Central Queensland Coal Project
Appendix 6e – Groundwater Model
Peer Review

Memorandum

Date 16 July 2020

RE **Central Queensland Coal groundwater model peer review – Stage 4**

Figure 2.1 Maximum rate and extinction depths applied across the model domain (Figure 7-7, HA report)

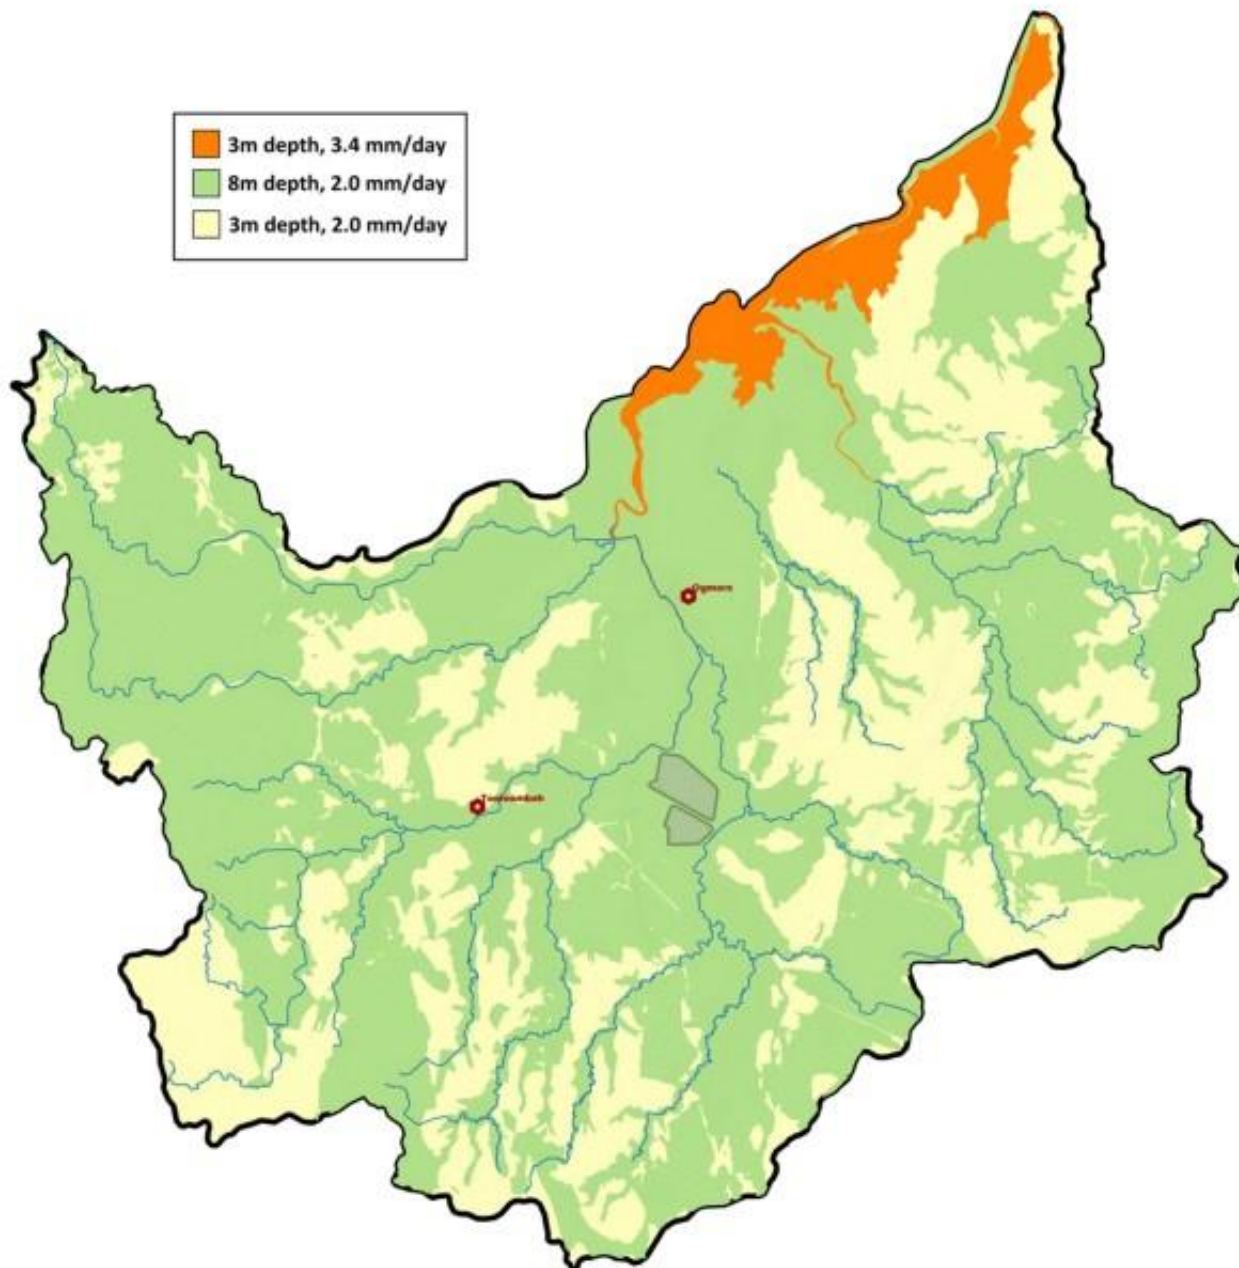
Extinction depths used to parameterise the MODFLOW evaporation package are reported to be based on maximum rooting depths for different vegetation types reported in Canadell et al (1996) and Shah et al. (2007). Canadell et al (1996) suggest maximum rooting depths for trees of 7-8 m, shrubs 5-6 m, herbaceous plants 2.5 m and crops 2 m. These depths are considered to be reasonably consistent with other similar studies and suggest that root depth and hence evapotranspiration losses are related to the type of ground cover or land use. As described in Section 3.4 of the HA report, land use in the model domain is dominated by agriculture (78%) predominantly grazing. However, rather than base modelled extinction depths on land use mapping it would appear based on Table 7-6 in the HA report that they have been based on outcrop geology mapping such that all areas mapped as Qpa, Qr, Qf and Qa on regional geology maps have been assigned extinction depths of 8 m. As shown in Figure 2.1 this results in extinction depths of 8 m being assumed across the majority of the modelling domain, despite clearing of the majority of this area for grazing purposes. Accordingly the Stage 3 review recommended a further impact sensitivity run be undertaken to confirm the sensitivity (or otherwise) of model predictions to the current extinction depth assumptions. The results of this additional run are presented in Attachment 18 of the HA report and discussed further in Section 2.2.12.

The very high evaporation losses predicted in isolated areas, particularly towards the southern boundary of the domain shown in Figure 2.2, were also queried with the modelling team during the Stage 3 review and attributed to high modelled water tables in Tertiary outcrop areas. Given the distance of these areas from the proposed mining operations this is considered unlikely to materially affect predictions.

Figure 2.3 Modelled predicted groundwater take – direct (daily average) inflow to Modelled Drain Cells [2020 to 2038] (Graph 8-1, HA report)

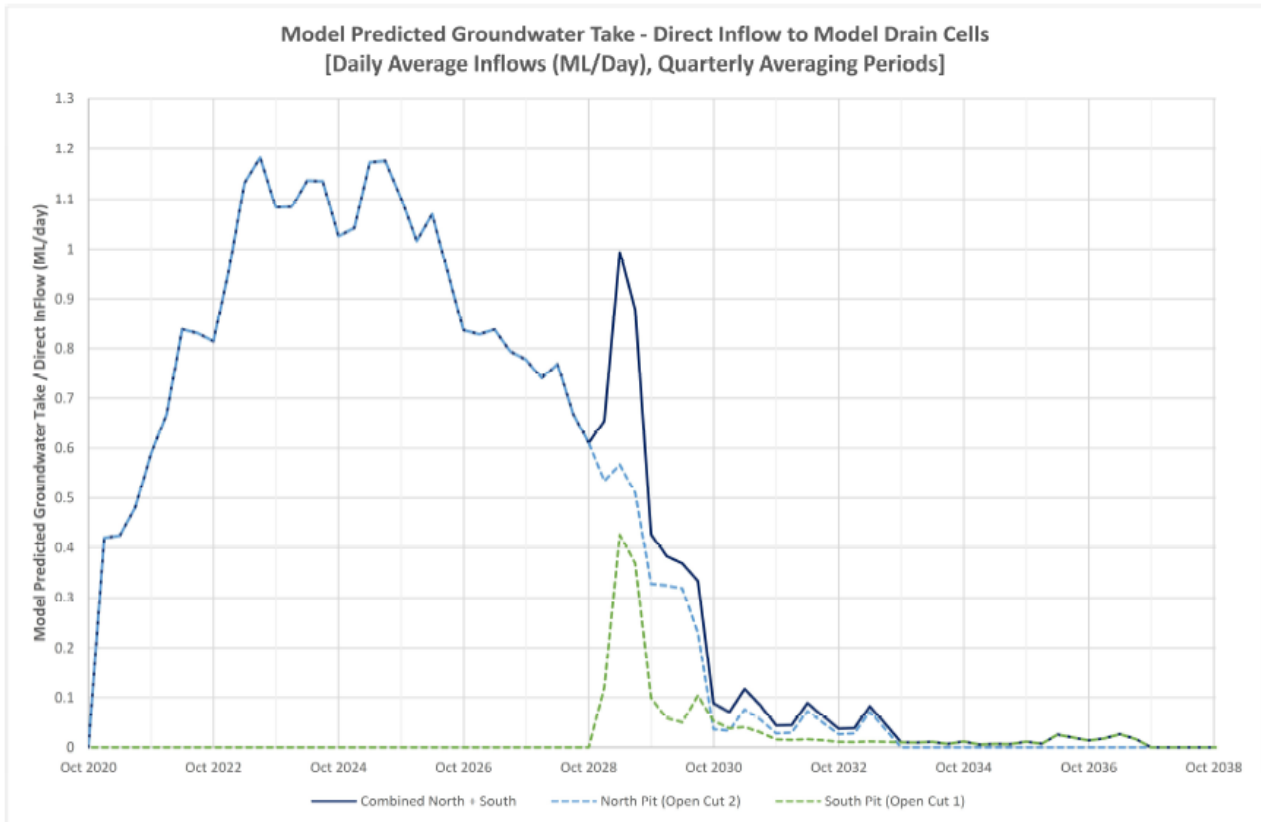
Predicted groundwater inflow to the two proposed open cuts is presented in Graph 8-1 of the HA report, a snapshot of which is presented below (Figure 2.3). The pattern of flows presented is plausible suggesting a relatively rapid increase in inflow during the initial development period, falling gradually thereafter as areas are progressively backfilled.

It should be stressed, however, that this plot is reported to be based on modelled drain flows only. Elsewhere the reporting suggests that evaporation may also be occurring from those parts of the open cut areas which have been backfilled. However, subsequent analysis of the raw model files provided suggests that this is not the case and that evaporation would only occur from backfilled areas once groundwater levels rise to within 8 m of the final post development ground level. As this is likely to only occur well after mining operations cease then modelled evaporation losses from the open cut area during mining are likely to be insignificant.

Figure 2.4 Model predicted flux – indirect baseflow changes/enhanced leakage during and post mining (Graph 8-3, HA report)

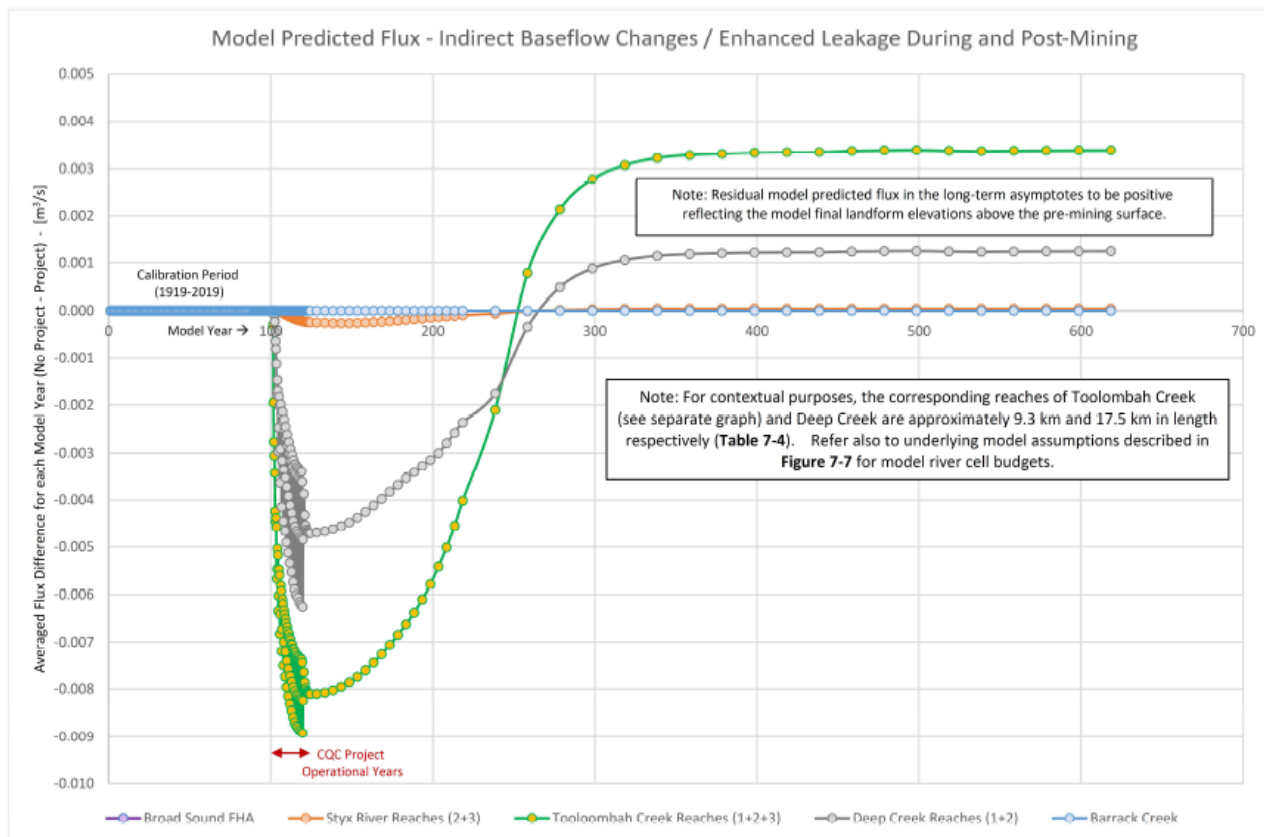
Predicted reductions in groundwater flow to Tooloombah and Deep creeks and other water courses are shown in Graph 8-3 of the HA report, a snapshot of which is presented below (Figure 2.4). As shown maximum impacts of up to 0.009 m³/s (equivalent to 0.78 ML/d) are predicted during mining in Tooloombah Creek, up to around 0.006 m³/s (equivalent to 0.52 ML/d) in Deep Creek and little or no impacts on groundwater discharge to other creeks. During the review process it was noted that these predicted impacts represent a significant proportion of the predicted mine inflows (Figure 2.3) particularly towards the end of the mine life. However, subsequent sensitivity runs testing different river bed conductance values (Section 2.2.12) suggested that the similarity of these flows was coincidental.

Post mining predictions suggest slight increases in flow to both Tooloombah and Deep creeks due to additional groundwater discharge from two out of pit waste rock emplacement areas which form part of the final landform. As discussed previously in Section 2.2.6 this is in part due to the relatively high recharge rates assigned to these waste rock emplacement areas.

Figure 2.5 99.7% Confidence Intervals of Probability of Exceedance – Peak Mine Inflows [Combined] – Additional Parameter Analysis Comparison with LF3 (Graph 8-6, HA report)

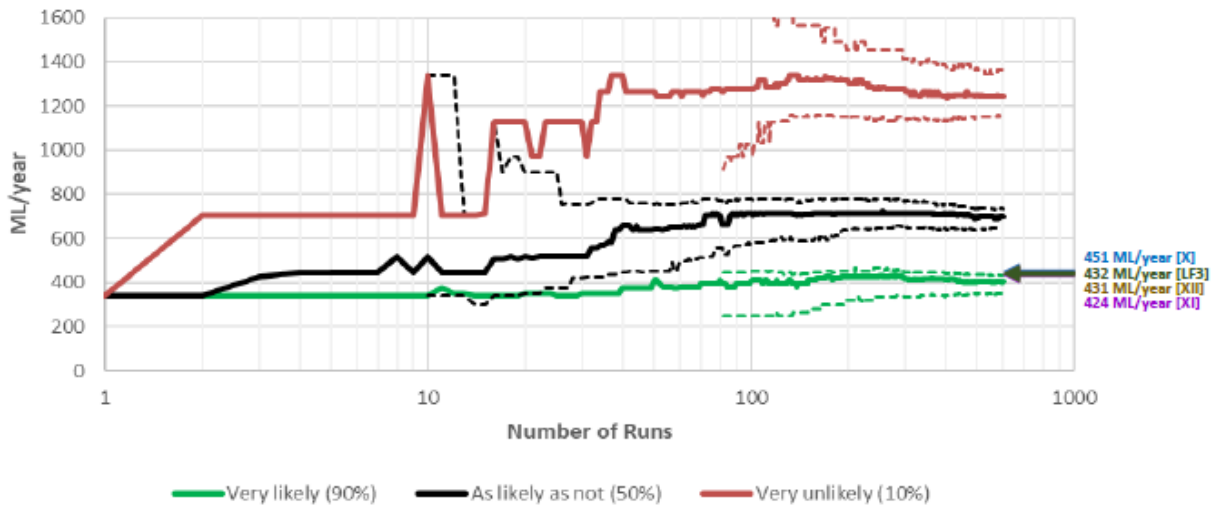
The review process also investigated why outputs generated using the baseline fully calibrated (LF3) parameter set to the 90th percentile of some key impact metrics (see Figure 2.5 and Figure 2.6) and close to the 10th percentile in others (see Figure 6 in Attachment 11 of the HA report). Given the approach adopted to generate alternative parameters for the uncertainty analysis described above, whereby the generated parameters were centred on the calibrated value, this was thought to be somewhat unusual, suggesting a possible bias in the values generated. However, subsequent analysis of the full parameter set generated for all 1,000 uncertainty analysis runs provided by HA confirmed that this was not the case. The only systematic 'bias' evident in the parameters sets related to the anisotropy of layers 12, 13 and 14. For these three layers an anisotropy value of one was calibrated and any parameters of less than one generated during the uncertainty analysis were justifiably rejected as being unrealistic. All 1,000 alternative anisotropy values generated for these layers in the uncertainty analysis were therefore higher than the fully calibrated LF3 parameter set.

Revised predictions based on these three additional scenarios are summarised in Attachment 18 of the HA report and also in Figure 2.5 and Figure 2.6 (above). Results for Scenario X tend to confirm that key model predictions are relatively insensitive to the extent of the area modelled using an 8 m extinction depth. However, results for Scenarios XI and XII suggest that key modelled predictions are relatively sensitive to the river bed conductance parameter. As would be expected reducing the river bed conductance generally results in less predicted leakage from the Tooloombah Creek (Figure 2.6) but also results in a more extensive area predicted to experience more than 2m of drawdown than that predicted using the fully calibrated LF3 parameter set or the 10th percentile of the uncertainty analysis output.
